Technical modifications and updating of the spare parts catalogues suitable for our scrubbing machines at 230V

→ Starting from serial number: 12001722 dated 21/05/12 (**baby e**, table 1102-10 R01, pos. 18)
13001015 dated 15/03/13 (**ruby 50e**, table 0502-11 R03, pos. 4)

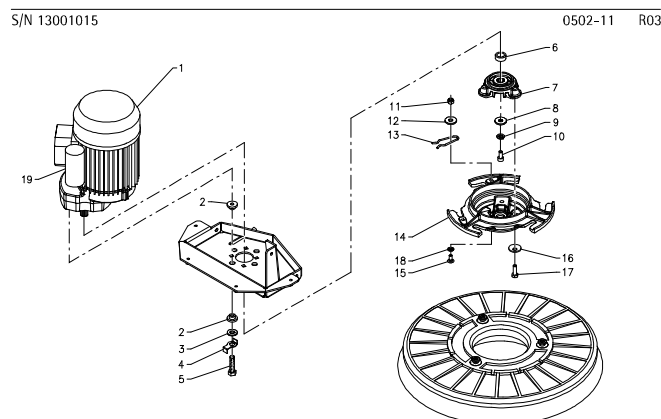
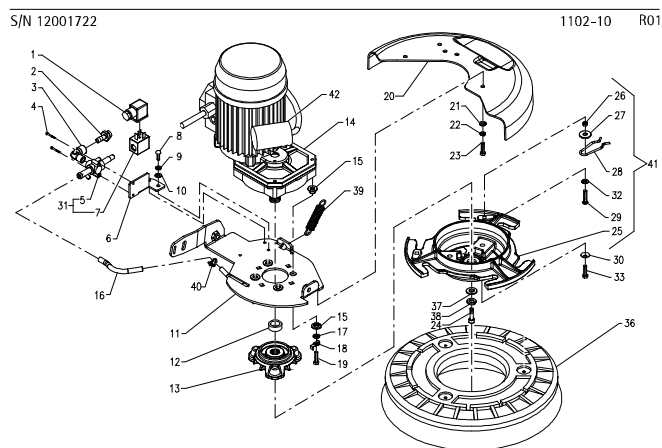
We have had some cases where, because of the vibrations, the screws that fix the geared motor to the brush base loosened themselves. We intervened replacing dowels and nuts with screws and by inserting safety washers between the screw heads and the brush base. With this modification it is not necessary anymore to block the screws with blocking glue.

→ Starting from serial number: 13001004 dated 13/03/13 (**ruby 50e**, table 0505-10 R01, pos. 52)

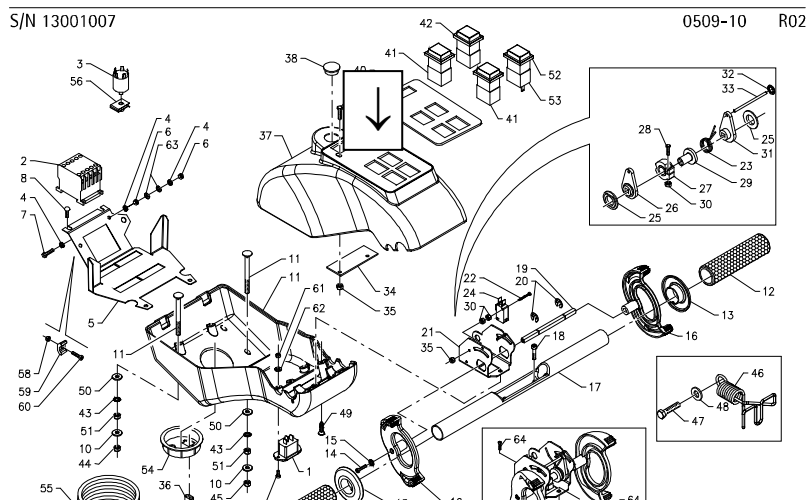
During some tests carried out we have verified that the label of the instrument board could get damaged near the two upper switch housings risking to enter in contact with electric parts. To avoid this problem we have realized a new cover having four holes instead of six ones. For spare parts the new cover can be sent in place of the previous one.

Take off: 49201020 handle bar cover

49201050 handle bar cover black

Add: 49205030 handle bar cover 4 holes

49205040 handle bar cover 4 holes black

➔ Starting from serial number: 13002524 dated 03/07/13 (**baby e**, table 1109-10 R00, pos. 12)

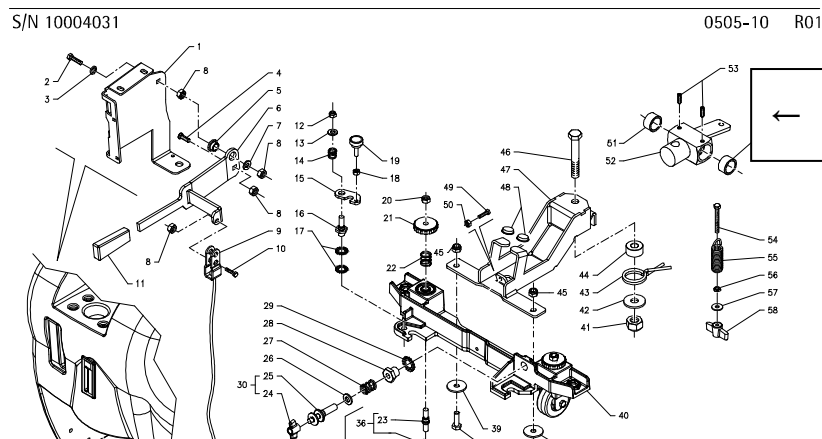
We have verified that in some cases the articulated joint with the square end did not permit a perfect oscillation of the arm. We have modified the joint and the lower profile of the arm to improve its oscillation in any working position. The new parts are interchangeable with the previous ones.

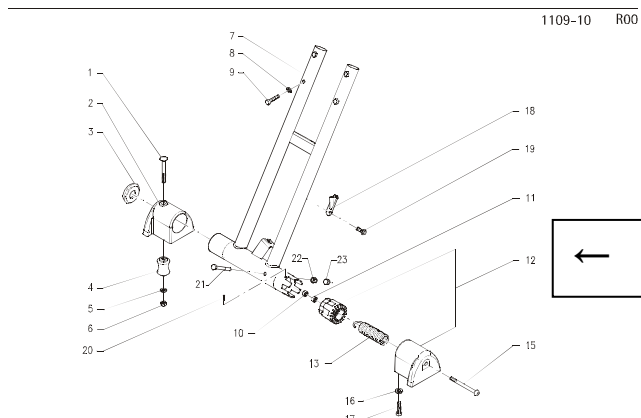
The profile of the coupling teeth between the left support and the toothed terminal (V1009010) has been modified.

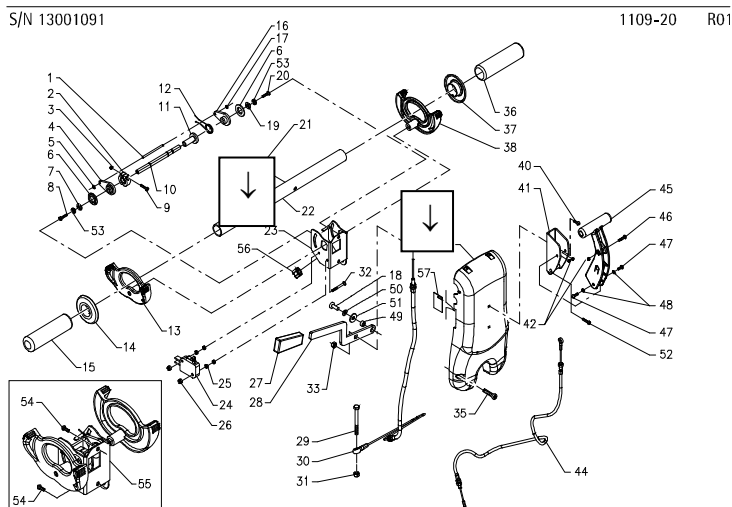
Shortly, there will be a new inner rubber holder for the squeegee on **baby e**.

It happened sometimes that the front squeegee rubber in some points was not sufficiently blocked and due to the friction with the floor it tended to slip off partially. To avoid this inconvenience, we have modified the inner rubber holder adding more gripping teeth. The new rubber holder is interchangeable with the previous one.
